## Attachment 4

### PLP Lake Powell Pipeline Project Responses to Participant Comments on PLP and Draft Study Reports

**Figure 1**  
**Marginal Price Curves (Consumption Charges) of Water Rate Structures in Utah,**  
**as of October 2004**

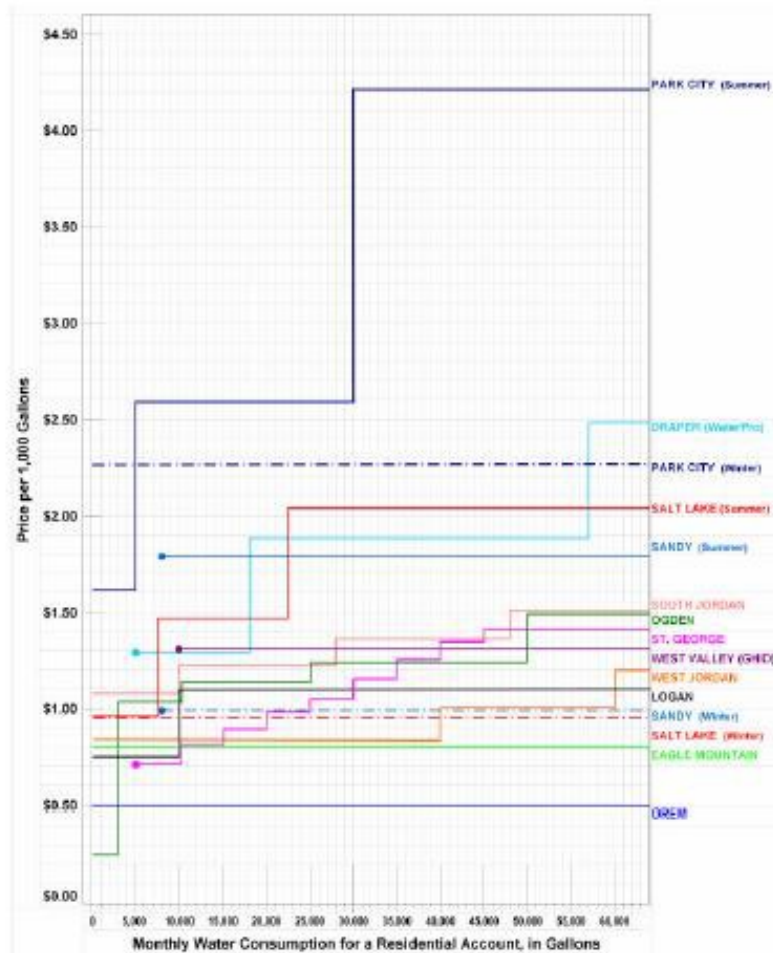
This chart (Figure 1) from WRA’s 2005 “Water Rate Structures in Utah: How Utah Cities Compare Using This Important Water Use Efficiency Tool” shows that St. George, WC’s largest city, doesn’t even compare well when compared with other Utah cities, in a state that’s been noted to have some of the cheapest water – if not the cheapest – in the nation.

**Figure 3.6 Comparison of City Water Rate Structures.** Some Utah cities have increasing block rate structures, but the rate increases are relatively flat when compared to cities in other states.

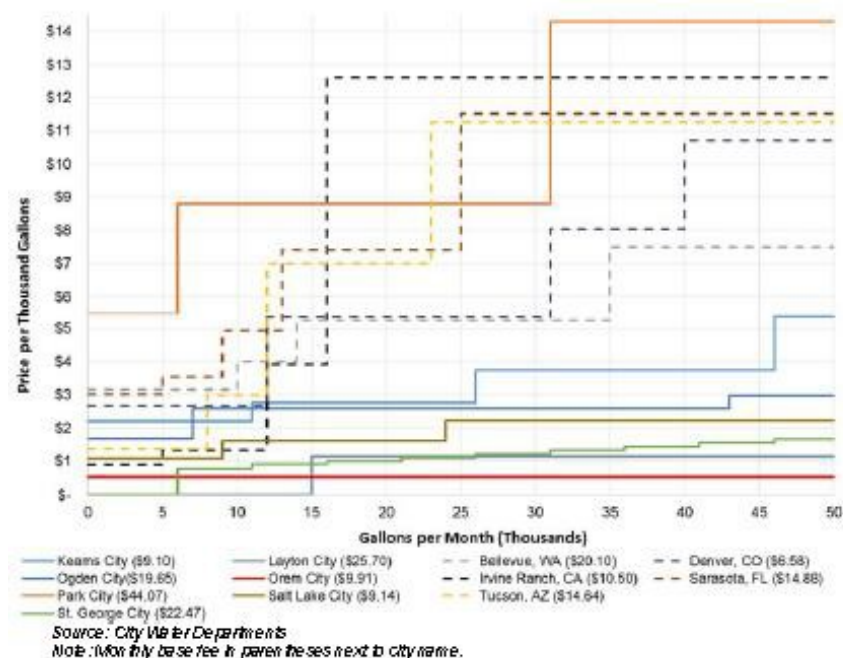
*This chart (Figure 3.6) from the Utah Division of Water Resources audit provides more evidence – comparing St. George water rates to rates of other cities in Utah as well as cities outside Utah.*

**Figure 2. Comparison of City Water Rate Structures.** A selected group of Utah Cities are shown to have flatter block rate structures when compared to those of other major western cities. More pronounced block rates tend to encourage conservation.

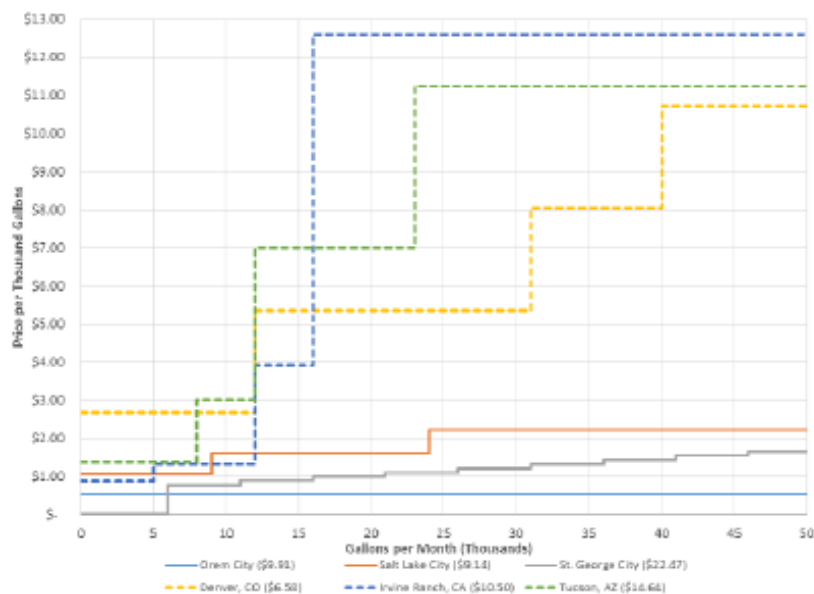
This chart (Figure 2) from the Utah Legislature audit of Utah's Division of Water Resources continues to support that WC's rate structure efforts are lacking.
